**From:** Scala, Mary Joy  
**Sent:** Thursday, January 21, 2016 2:01 PM  
**To:** Powe, Gregory; Woodard, Keith  
**Subject:** BAR Action Jan 19, 2016 – 200 2nd Street SW

**RE: Certificate of Appropriateness Application**  
BAR 16-01-01  
200 Second Street SW  
Tax Parcel 280069000, 280071000-280075000  
Powe Studio Architects, Applicant/Market Plaza LLC, Owner  
Refinements to building and plaza and landscape design

**CITY OF CHARLOTTESVILLE  
BOARD OF ARCHITECTURAL REVIEW  
STAFF REPORT  
January 19, 2016**

Subject: **Certificate of Appropriateness Amendment:  
Market Plaza: Site and Building Design Refinements**

Plaza Southeast View

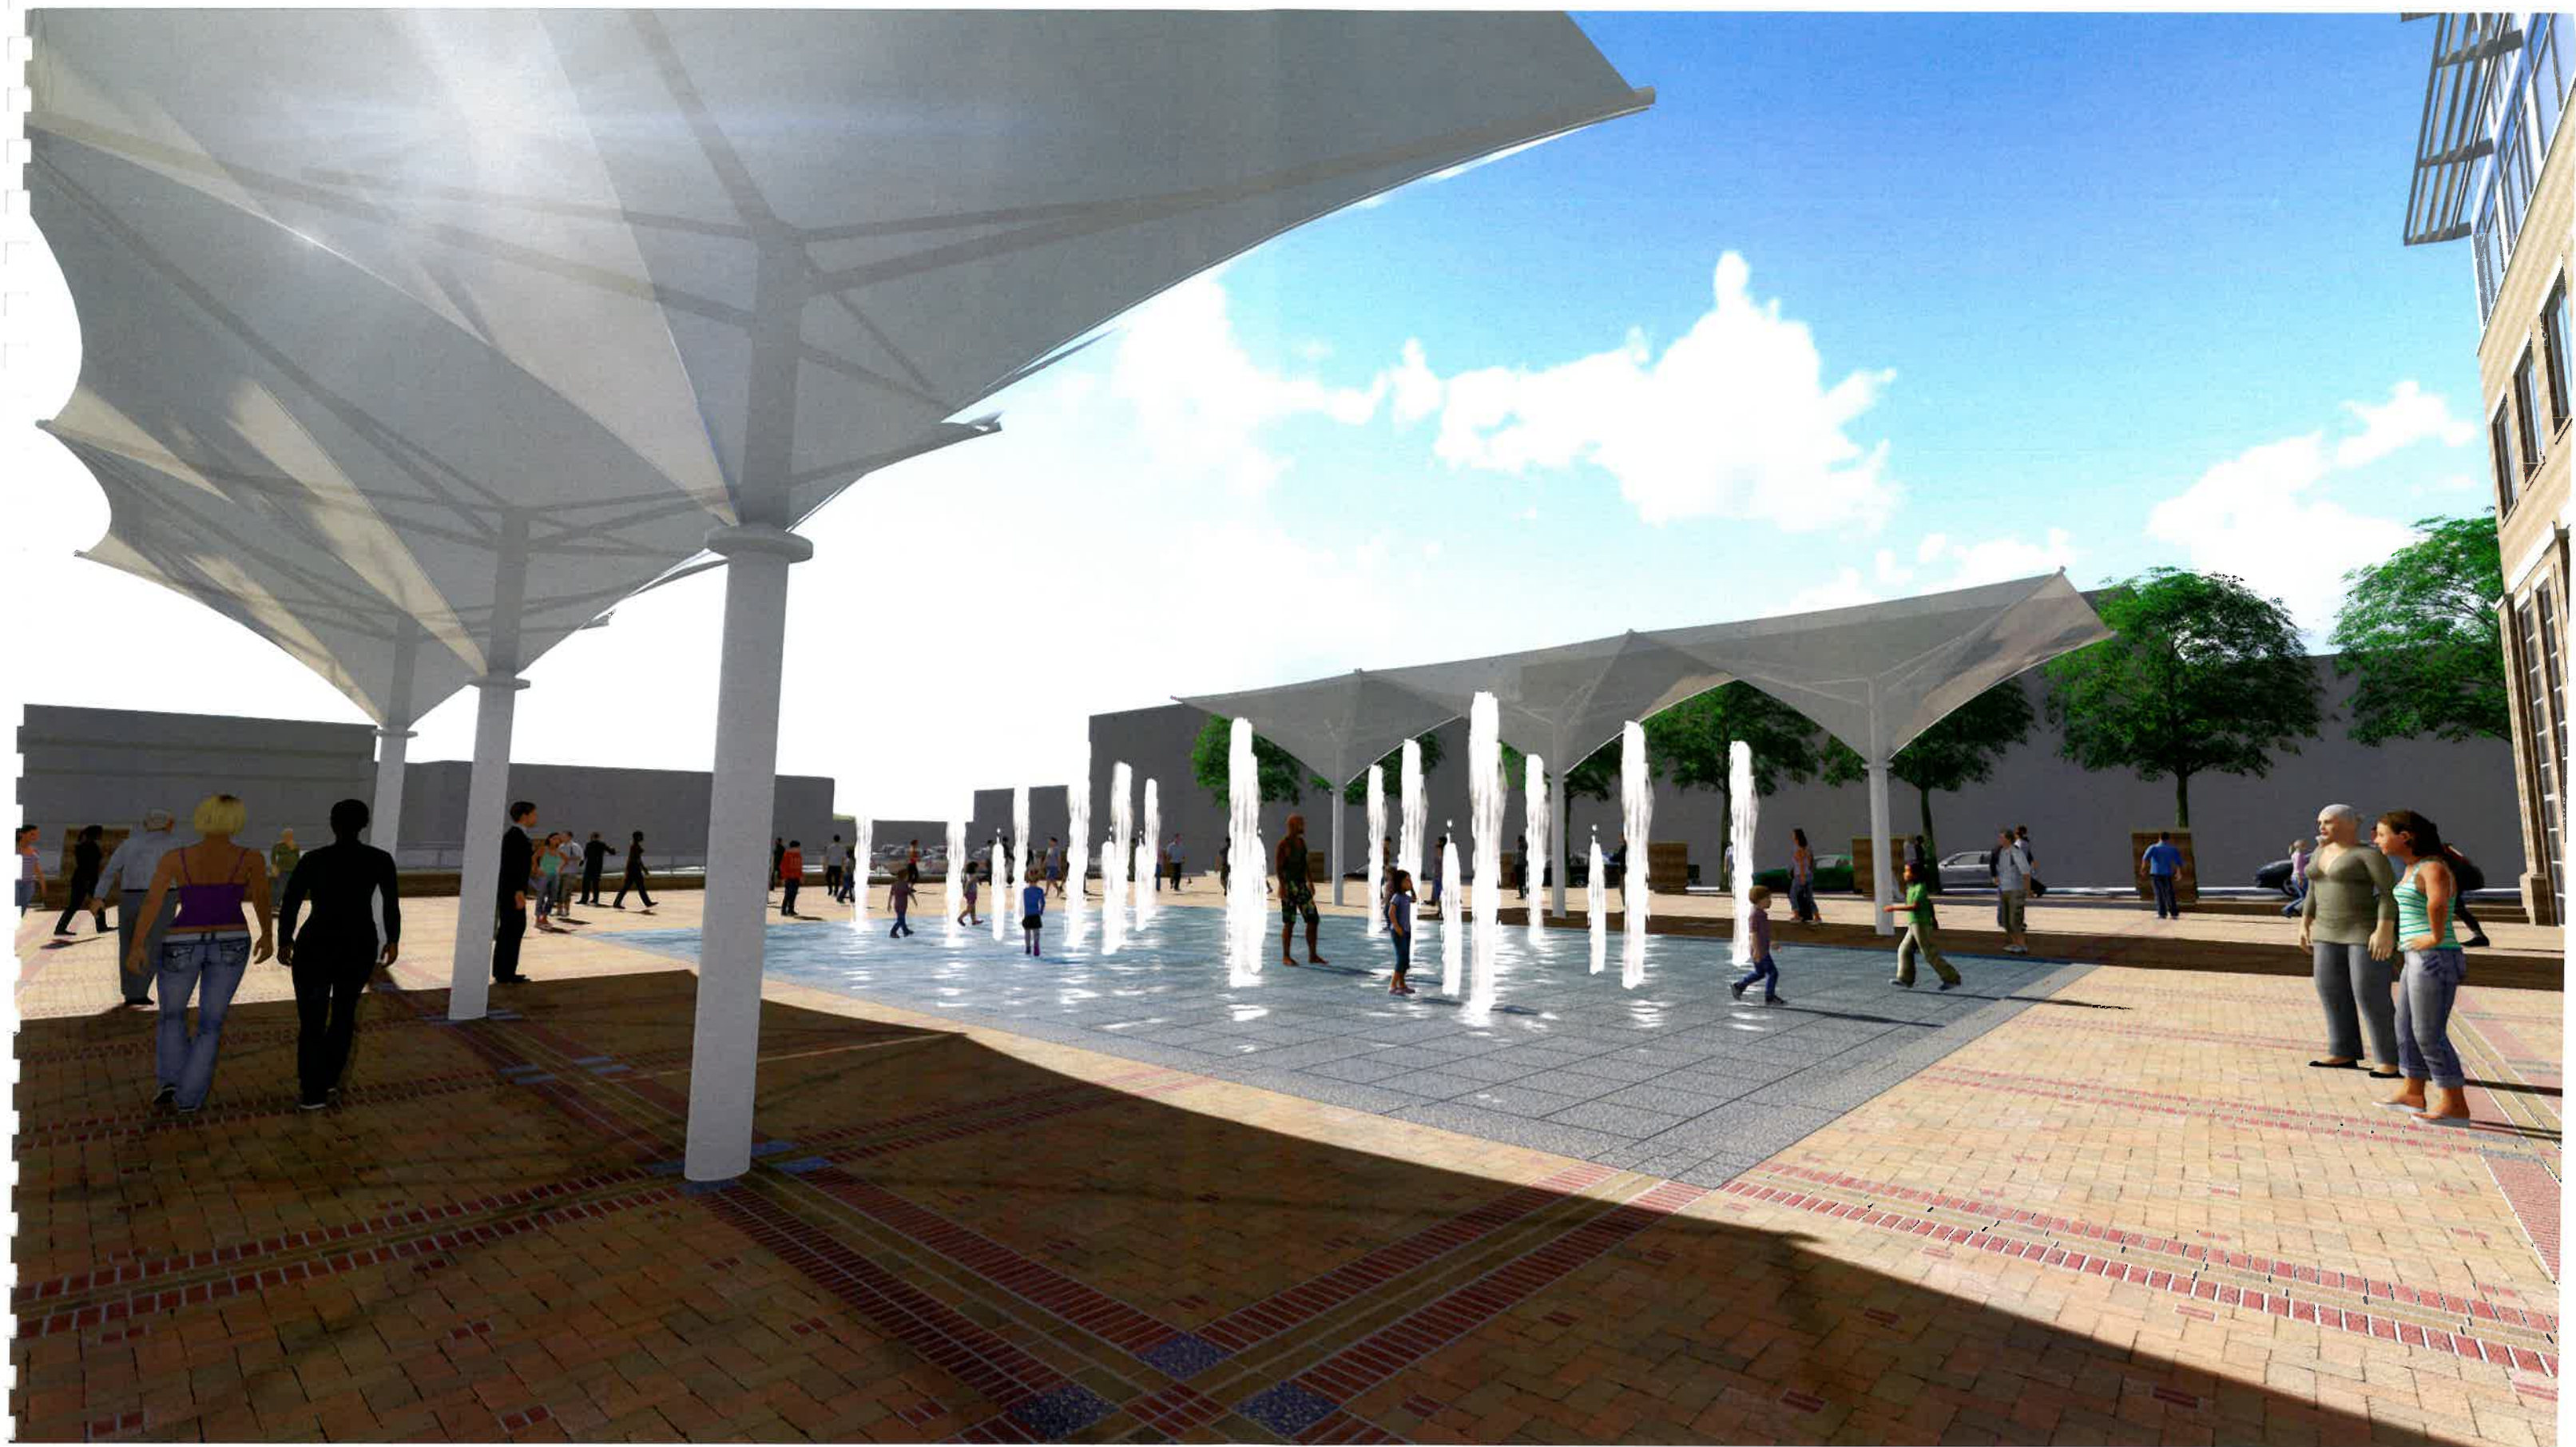
**Plaza Centerpiece Design Revision:** A number of City officials and staffers, particularly Parks and Recreation and City Market staff have expressed concerns about our most recent plaza design which introduced trees onto the plaza as its centerpiece in lieu of the original fountain design. The Developer has therefore requested that we return to a fountain centerpiece with simplified solar shading structures.

- The Plaza centerpiece is now a scrim fountain with water jets on a 40x60 foot field of granite pavers.
- The tents have been revised to (6) 20 by 20 foot upturned canopies as illustrated with renderings in this submission (drained through their vertical support pipe columns)
- The east wall of the Plaza has been re-proportioned, and the brick infill walls have been changed to glass guardrails.
- The First Street elevation of the building has been re-proportioned, per BAR comments, to remove the brick which had projected into fourth floor curtainwall.

South Elevation

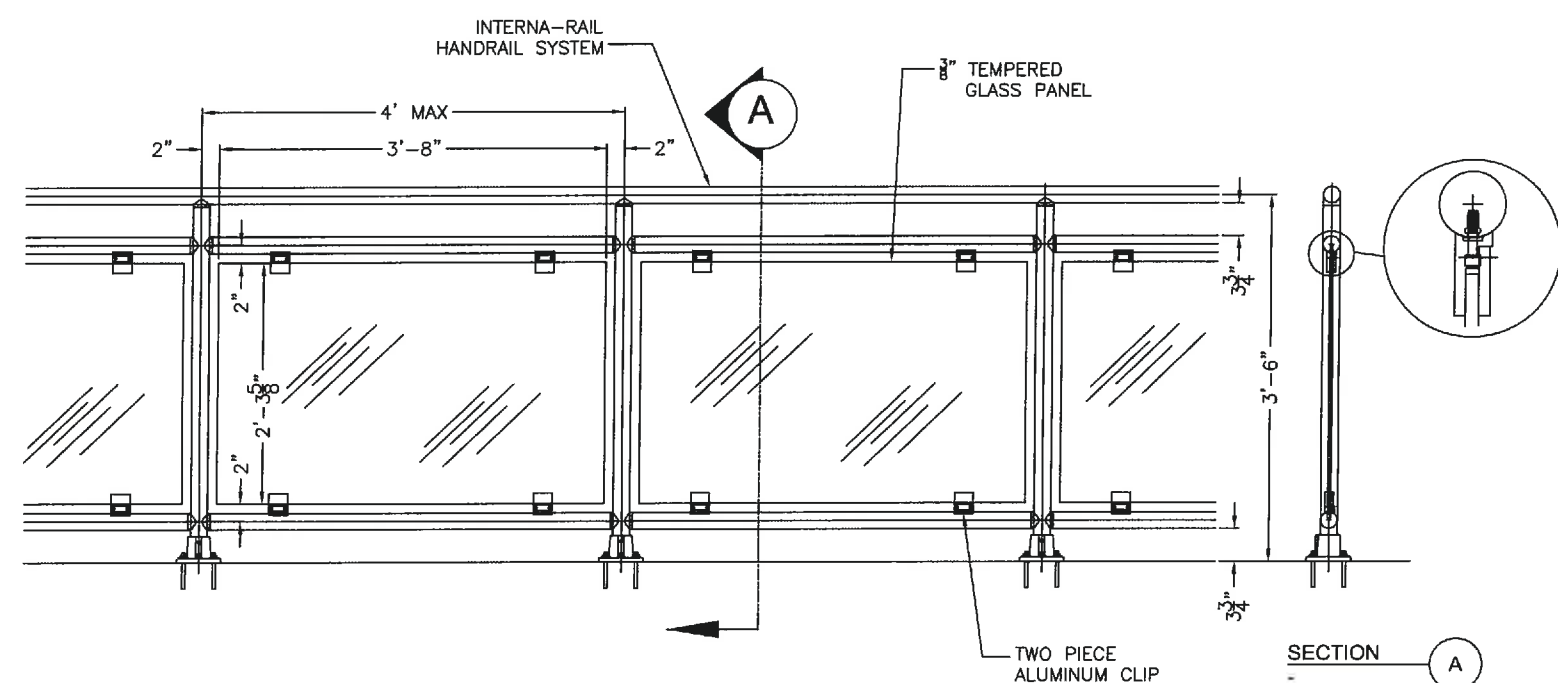
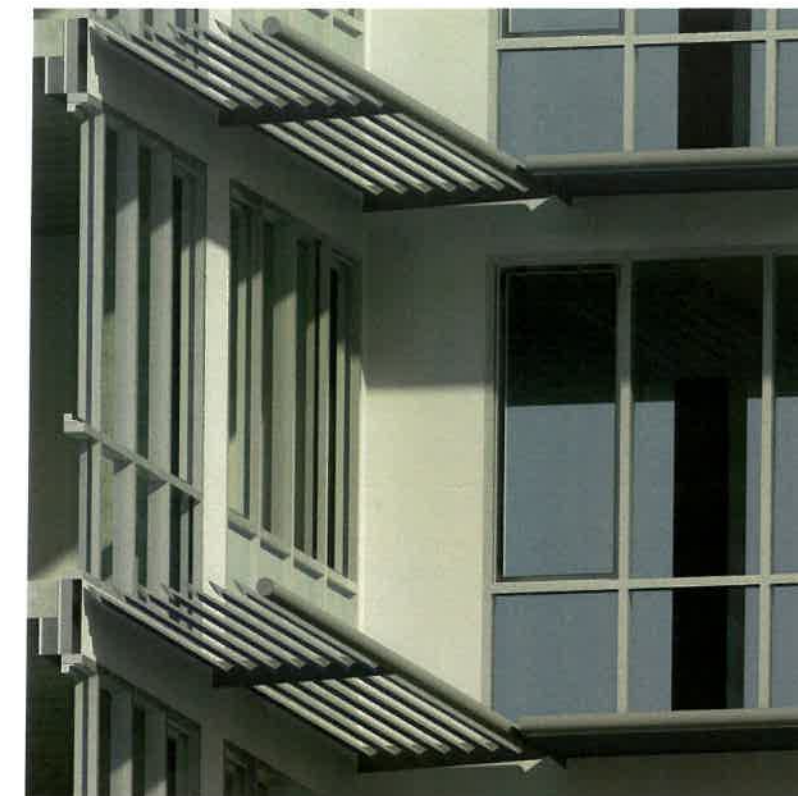
- The South Street elevation of the building has been re-proportioned, per BAR comments to remove the brick which had projected into fourth floor curtainwall.

- The exterior steps at the South Street egress stair have been eliminated.
- The parapets on the upper roofs have been deepened 8 inches to accommodate roof build up and a vegetated (green) roof.

- Translucent glass (white) is indicated at the South Street egress stair to block views from the stairway onto the private terraces.
- A specific brise soleil product has been selected for the curtainwall assembly. Detailed information is included in this submission.

Tents

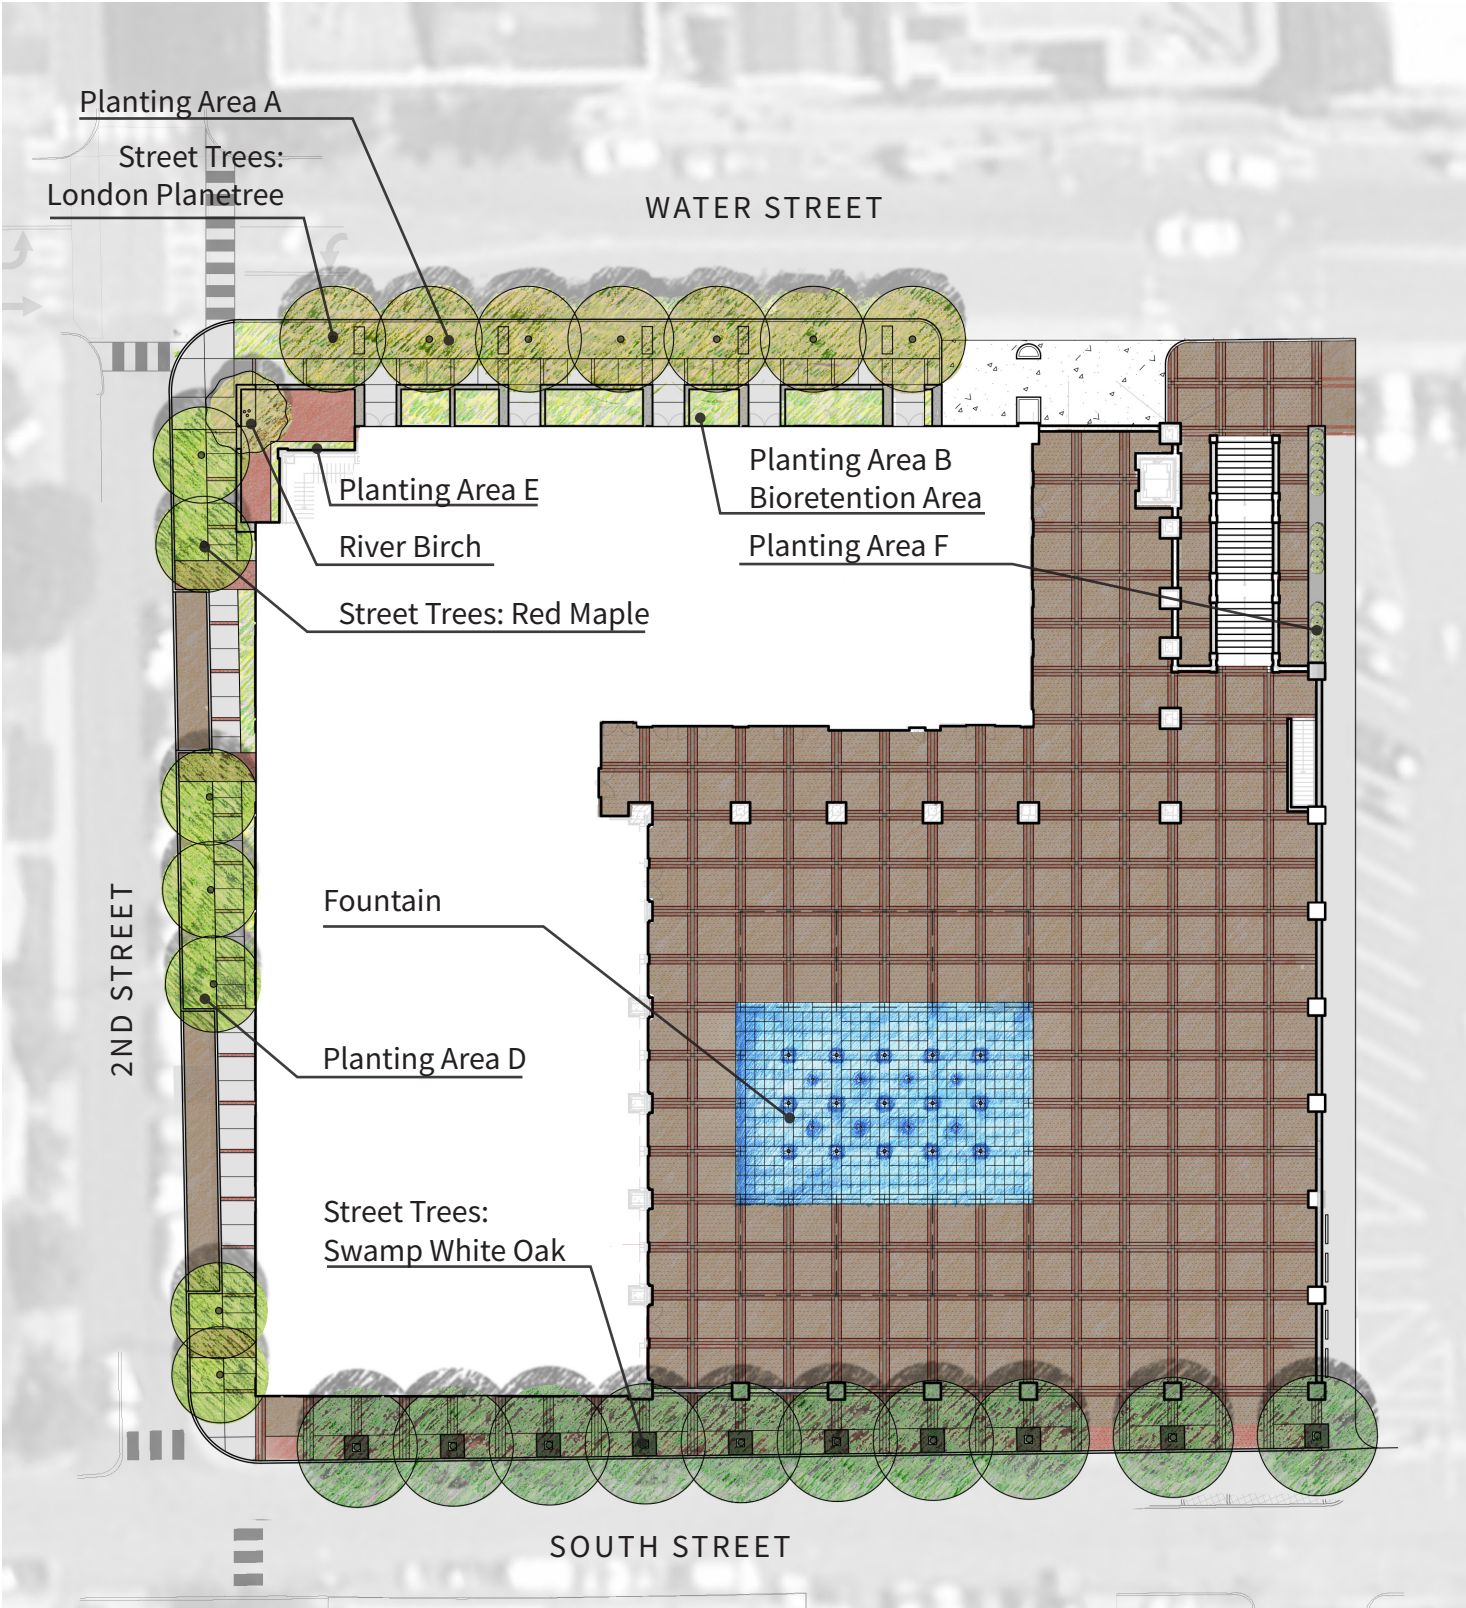
**Miller moved to find that the proposed changes to the site and building satisfy the BAR's criteria and guidelines, and are compatible with this property and other properties in the Downtown ADC District, and that the BAR approves the inverted tents, the fountain design, the spandrel glass, the change to the 1<sup>st</sup> Street and South Street elevations re-proportioned to remove the brick projecting into curtain wall, the east wall of the plaza, the details of the previously approved aluminum and glass railing system, the new building elevations as presented in the packet, the removal of the hockey stick lights, and the brise-soleils.**
